# State of West Virginia Purchase Order

Order Number:	CPO 0211 4004 GSD2300000002 11	Procurement Folder:	969527
Document Name:	Building 4 Renovations Project	Reason for Modification:	Change Order #7 To increase the contract.
Document Description:	Building 4 Renovations Project		
Procurement Type:	Central Purchase Order		
Buyer Name:	Melissa Pettrey		
Telephone:	(304) 558-0094		
Email:	melissa.k.pettrey@wv.gov		
Shipping Method:	Best Way	Effective Start Date:	2022-10-03
Free on Board:	FOB Dest, Freight Prepaid	Effective End Date:	2024-12-25

## Document G701® – 2017

**PROJECT: (Name and address)**  
22010.00 Building Four Renovations  
Project  
112 California Avenue, Charleston, WV  
25305

**RFI #:** 69  
**Date:** 12/11/2023  
**Job:** 22-22 State Office Building 4 Renov  
**Phone:**

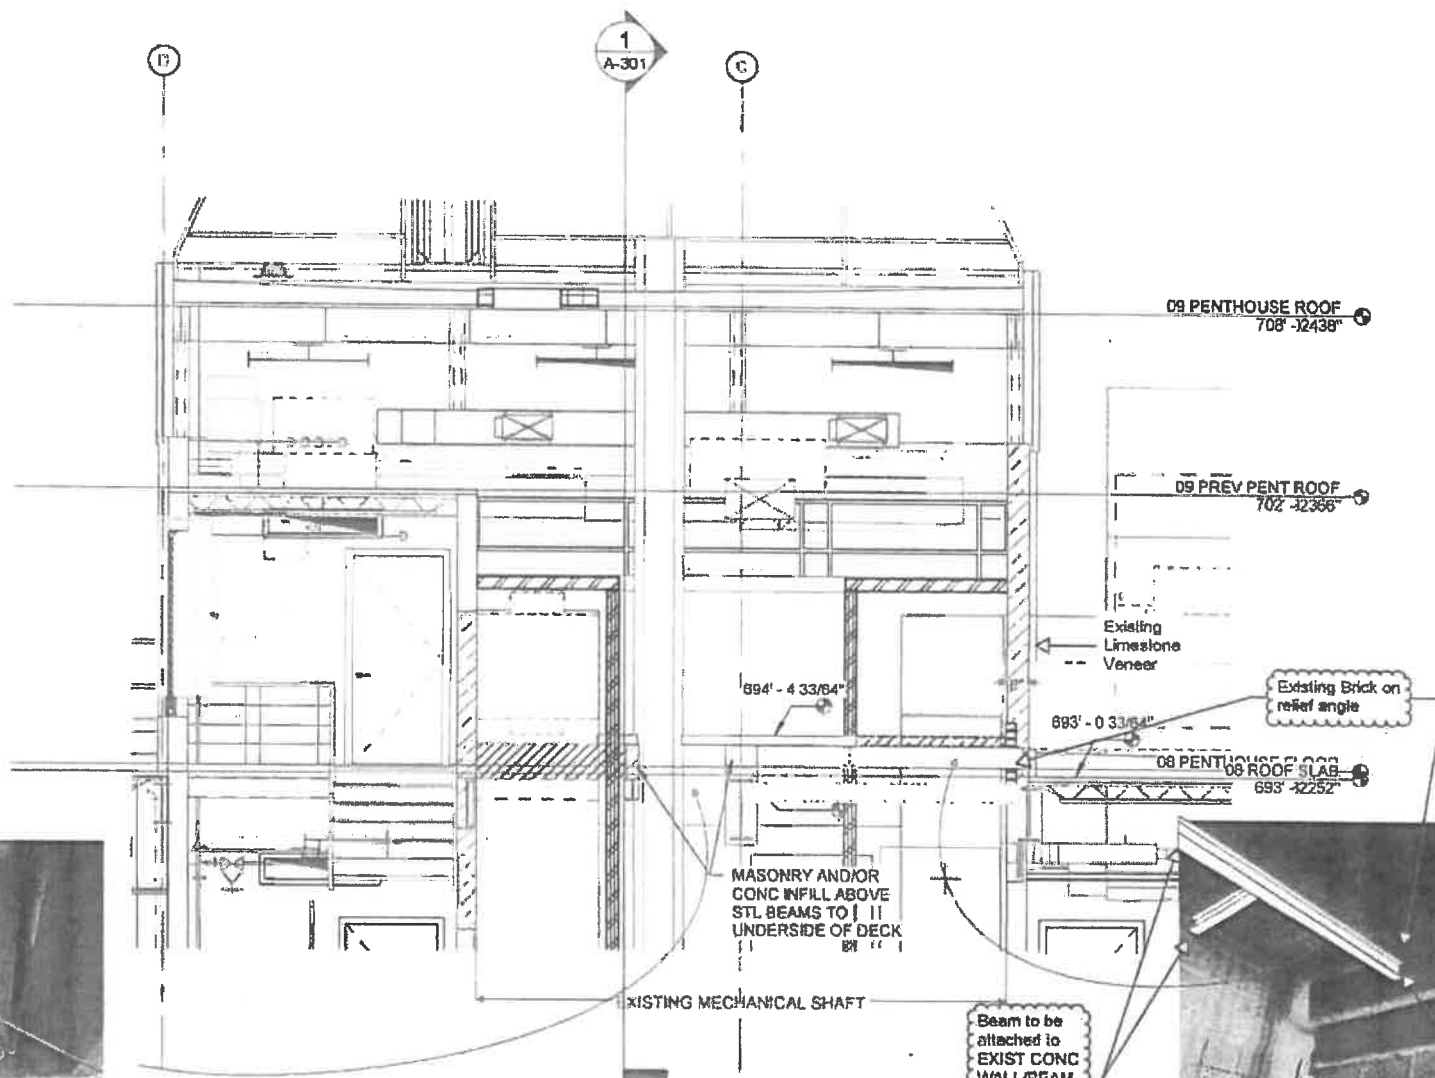
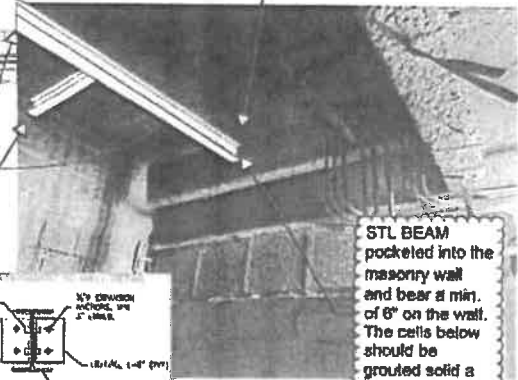
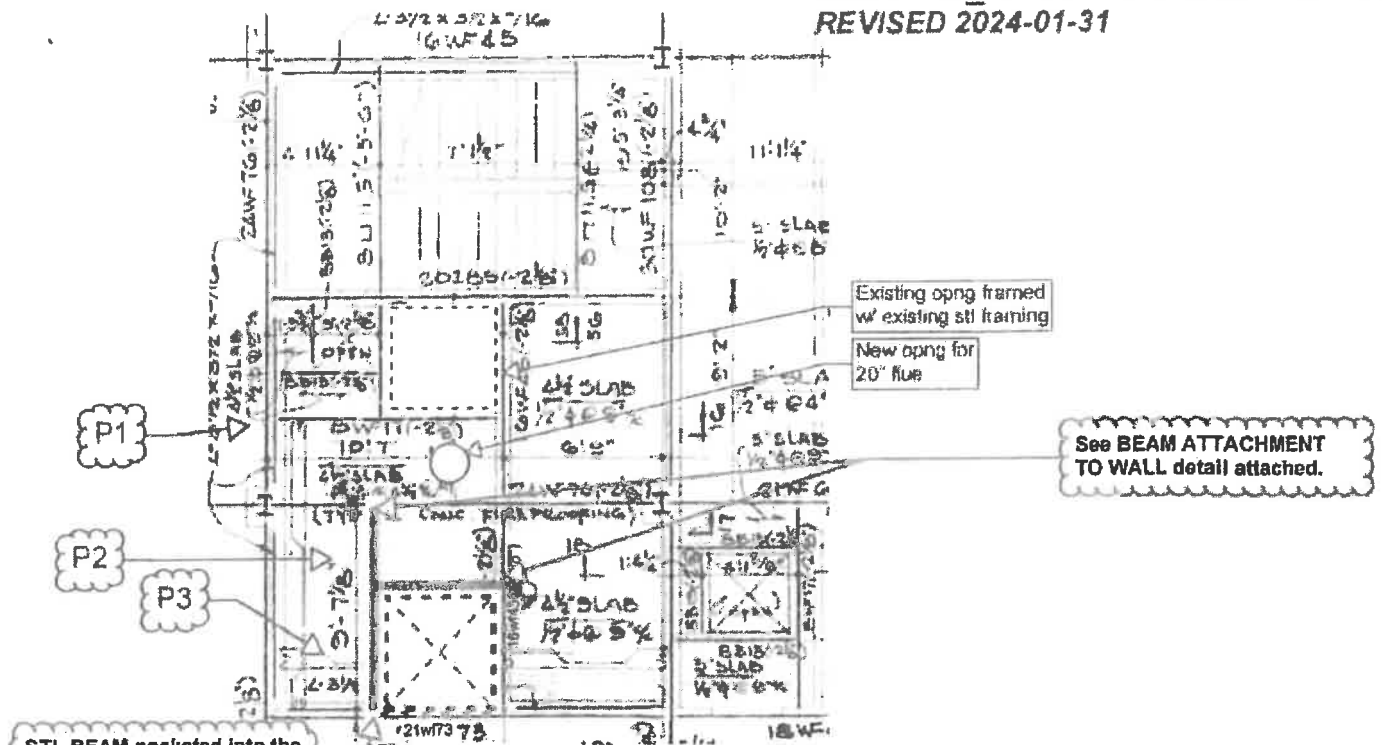
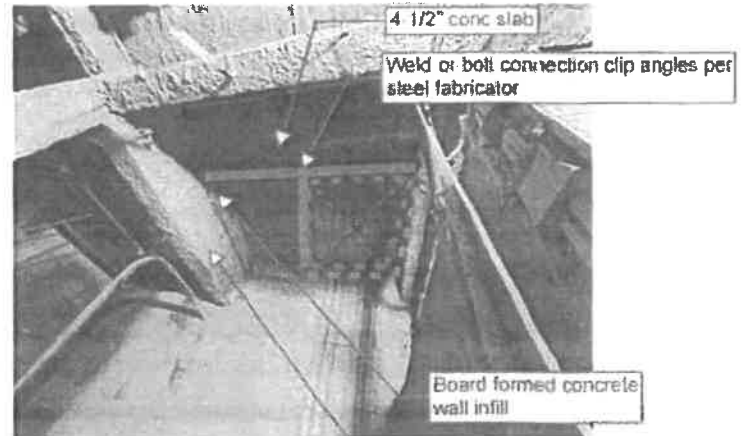
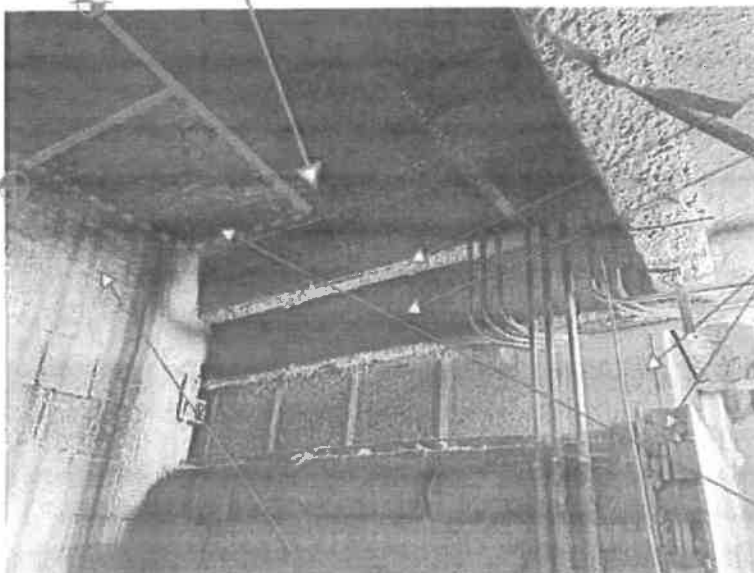
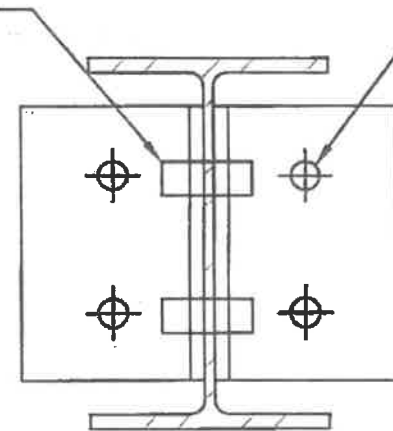
We need additional information regarding the Intent at the Penthouse Concrete Floor associated with the HVAC Ductwork from the Shaft. Reference Drawings AD-108, A-108, A-301, Detail 2 on A-302, S-102, and Detail 2 on H208, we do not see any information that designates new openings were required to be cut out in the existing concrete slab at the Penthouse or any Structural Steel Support for these required openings to allow for the New Flue and the New Ductwork on the North Side of the Shaft. Please advise.

See two page attachment (pages 3-5 of 9) for the following responses.

See BEAM ATTACHMENT TO WALL detail on page 5 for new W8x18 beams to concrete walls. (x2)

W8x18 beams pocketed into the south masonry wall and bear a min. of 6" on the wall. The cells below should be grouted solid a min. of 16". (x1)

Steel fabricator to detail the perpendicular short/long W8x18 beam connection (x1)

Beam to be attached to EXIST CONC WALL/BEAM INFILL per previous detail

STL BEAM pocketed into the masonry wall and bear a min. of 6" on the wall. The cells below should be grouted solid a min. of 16".

SEE BEAM ATTACHMENT TO WALL DETAIL ON NEXT PAGE

**RFI #:** 90  
**Date:** 2/14/2024  
**Job:** 22-22 State Office Building 4 Renov  
**Phone:**

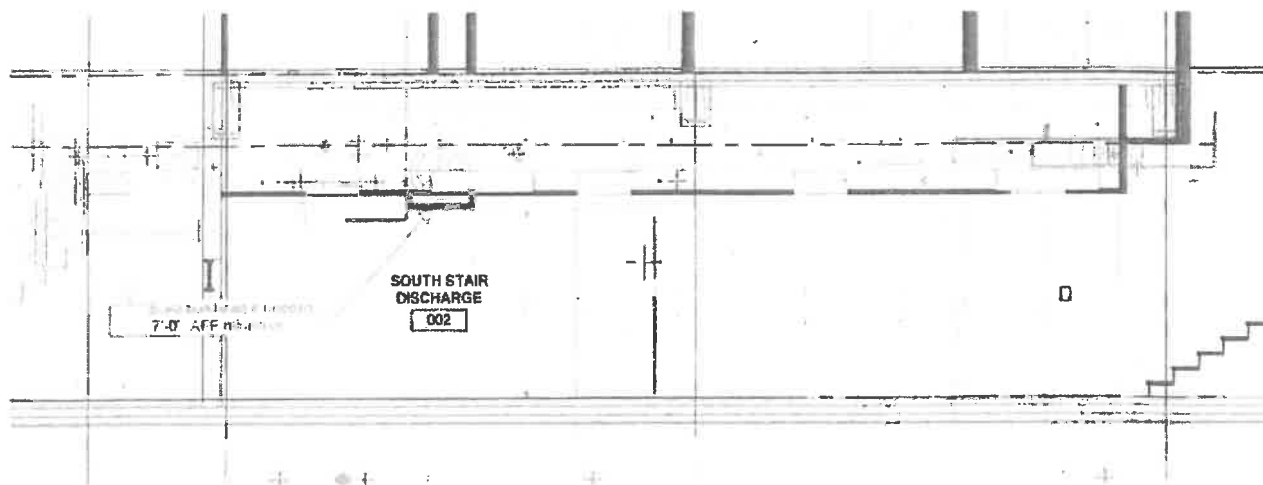
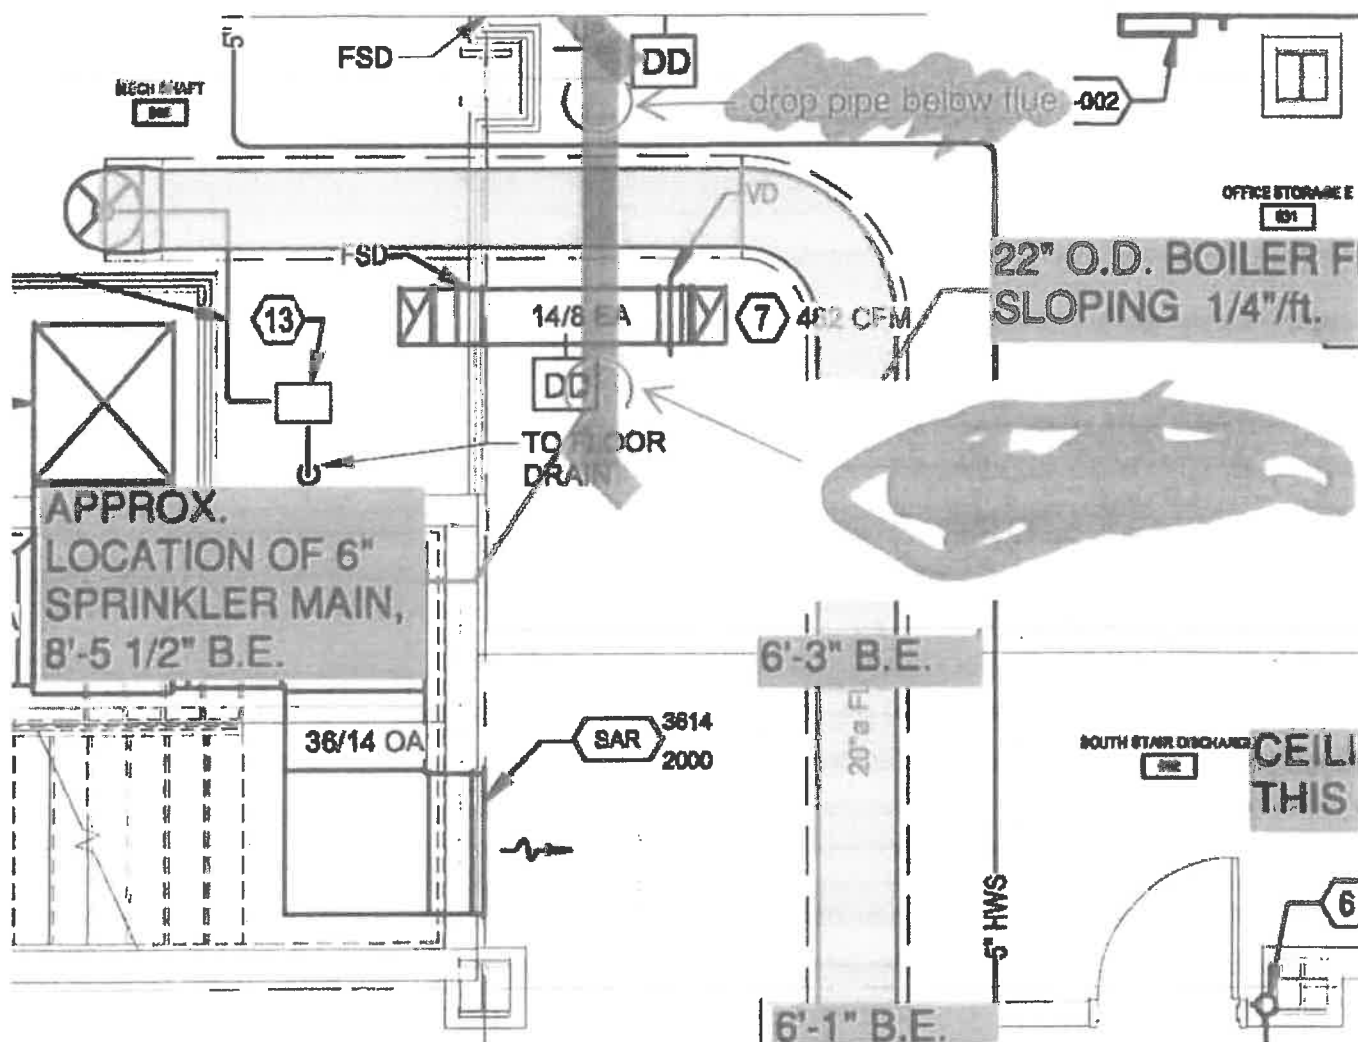
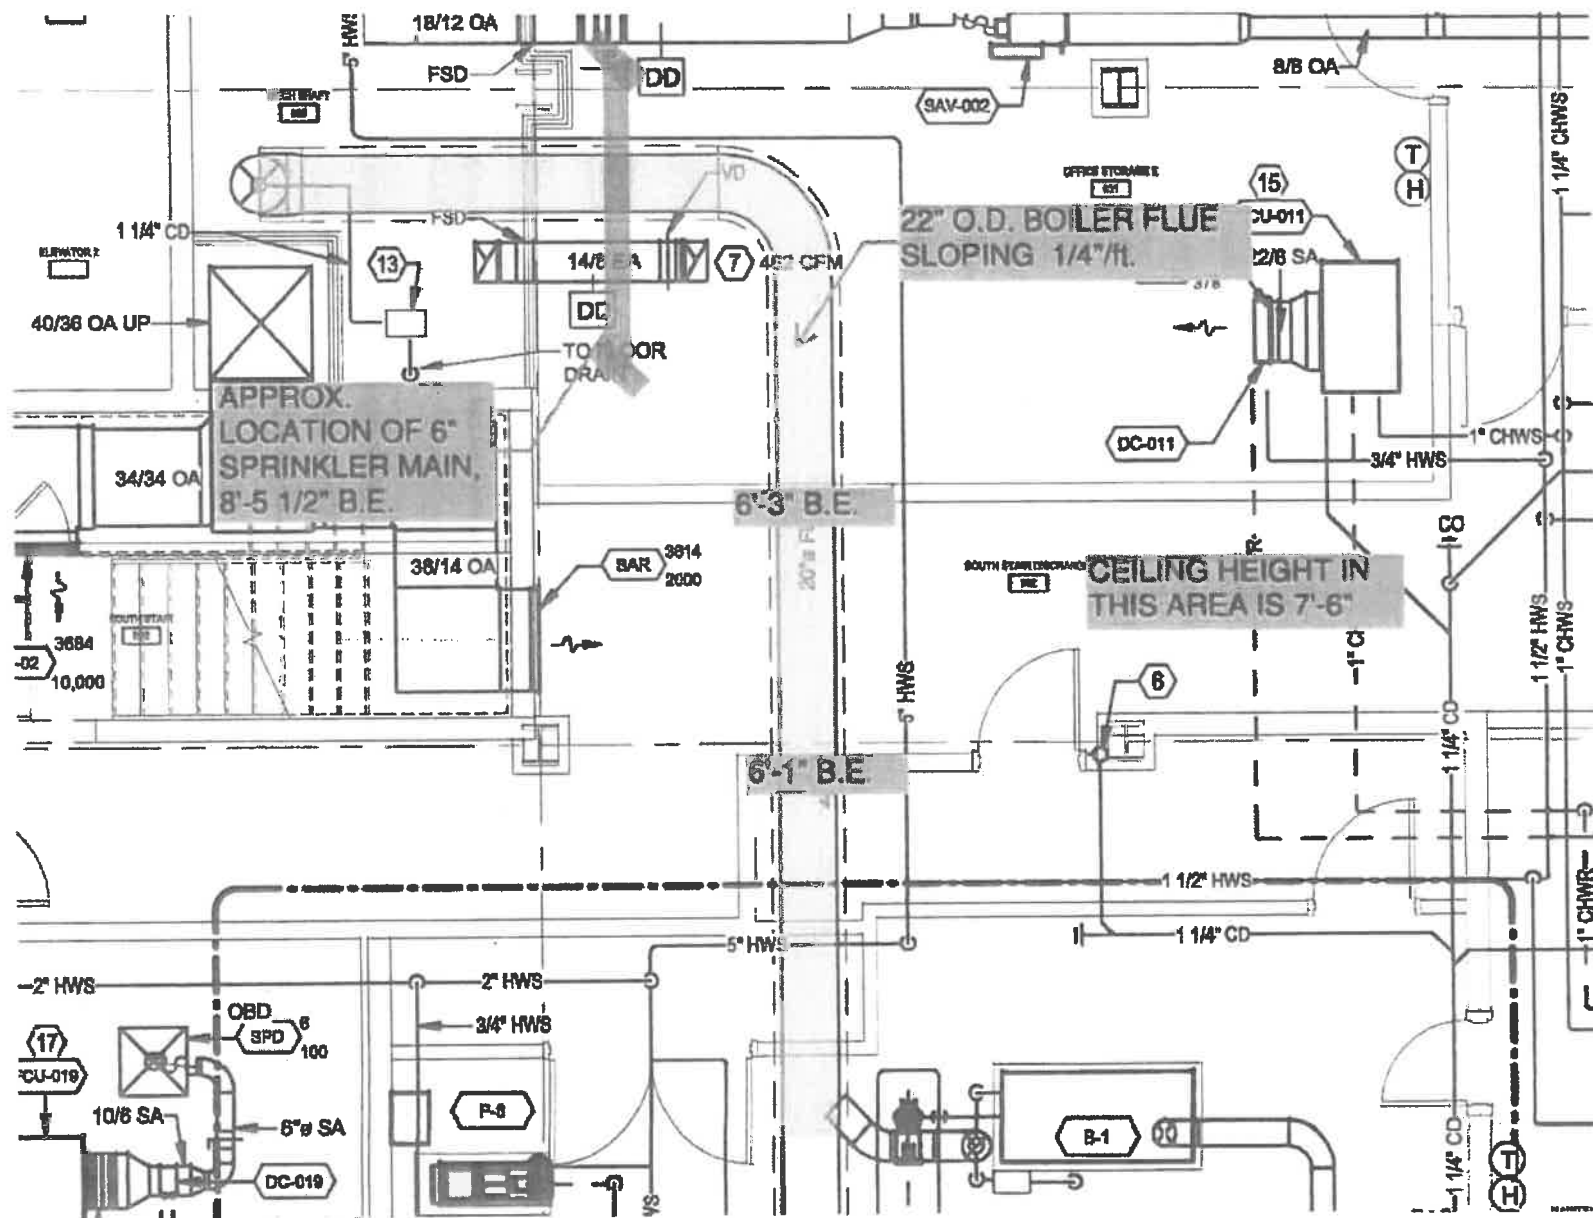
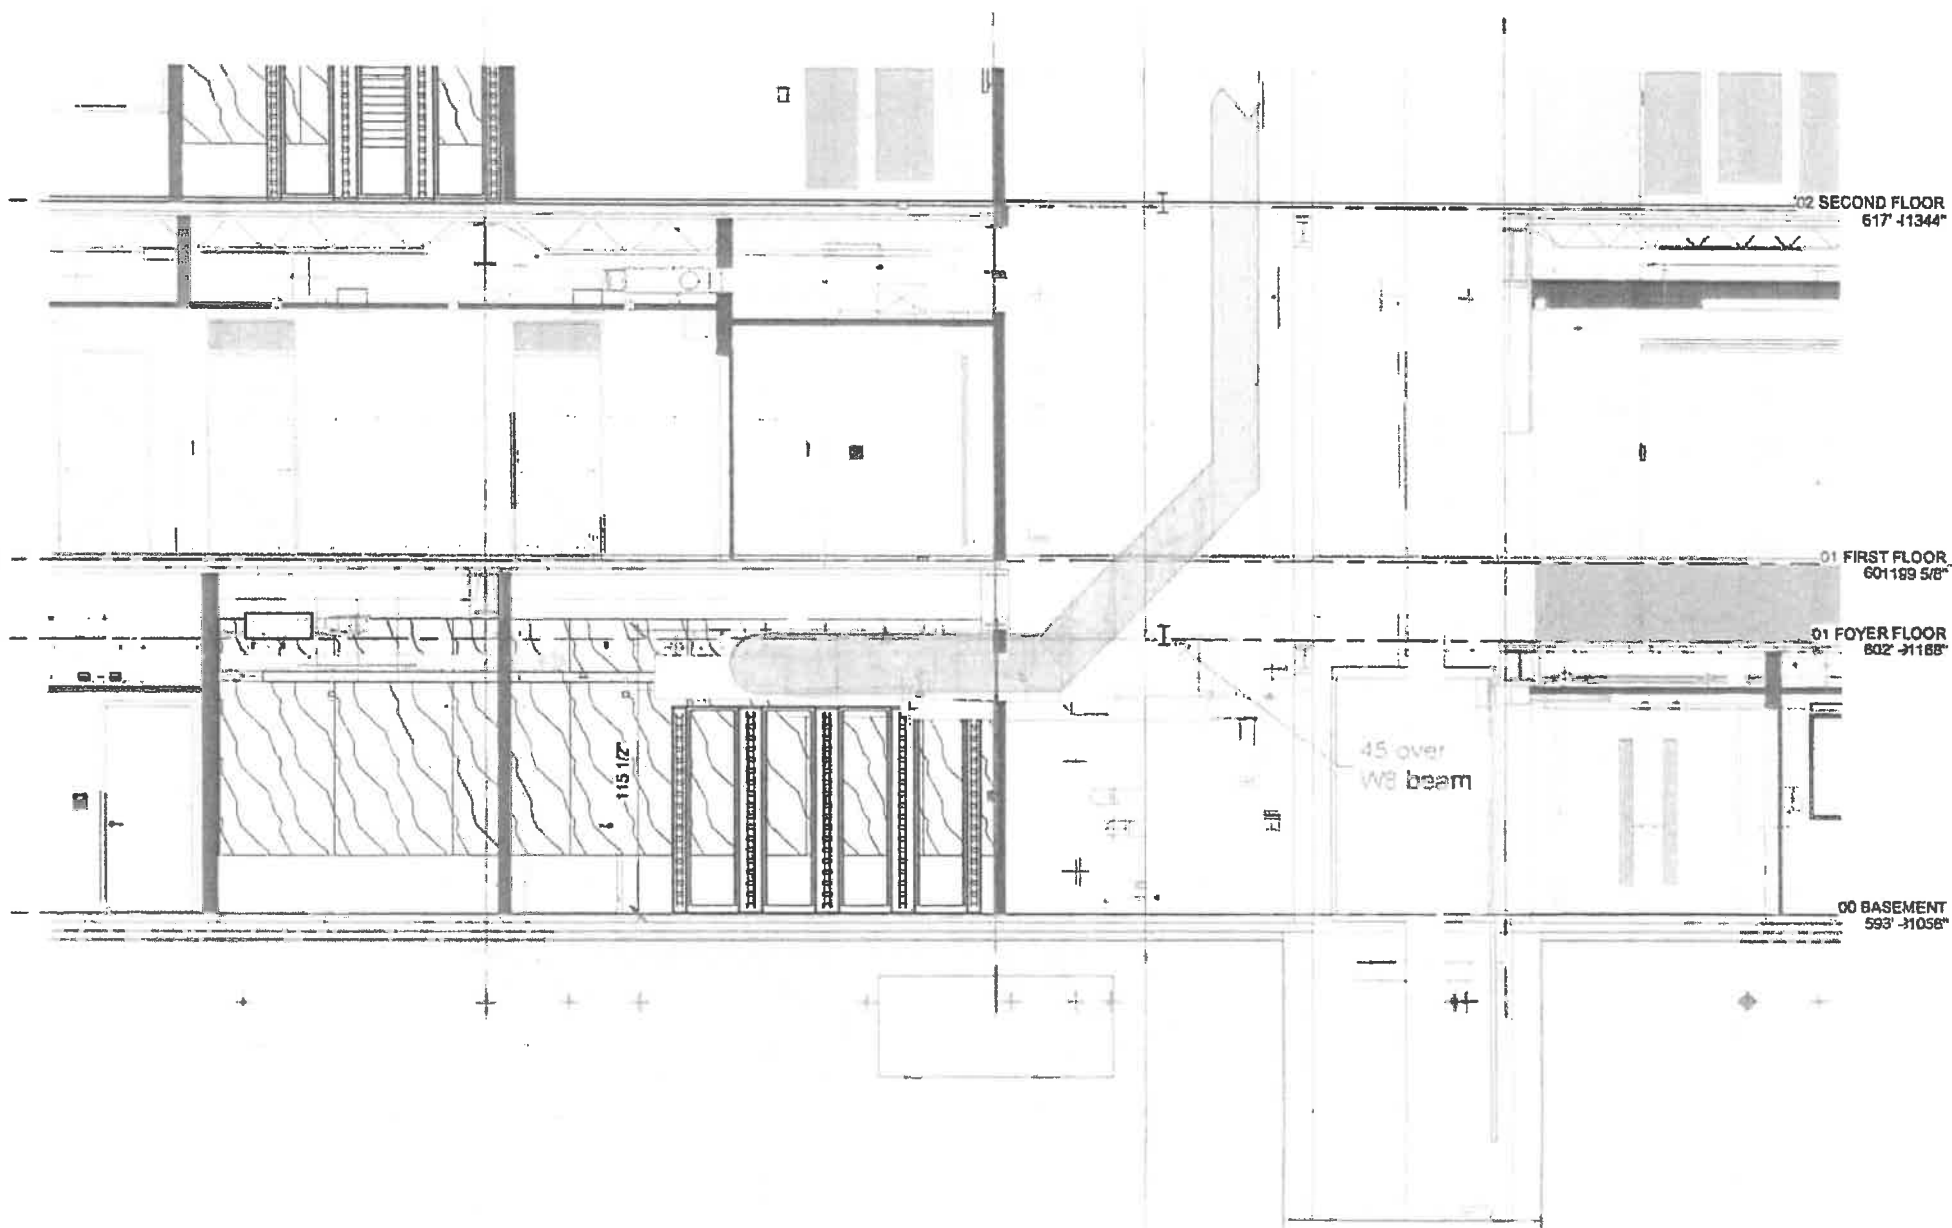
There is a 20" boiler flue (22" OD) which comes out of the mechanical shaft in the basement and crosses over South Stair Discharge 002. The elevation of this flue must be under an 8" steel beam, which is 9'-2 1/2" to the bottom elevation (BE), and under a 6" sprinkler main located under this beam, which is 8'-5 1/2" BE. The boiler flue slopes from the mechanical shaft, which puts it at 6'-1"-6'3" going across the South Stair Discharge 002. Ceiling heights in this area are 7'-6". See attached for these areas as shown on HVAC Plan H200. We do not see a way to raise the boiler flue to be above the ceiling height in this area. Please advise.

I concur. I think modifying the sprinkler pipe is going to be easier than trying to work the flue around the pipe. I'd drop the sprinkler pipe to run under the flue and then rise up after the ductwork.
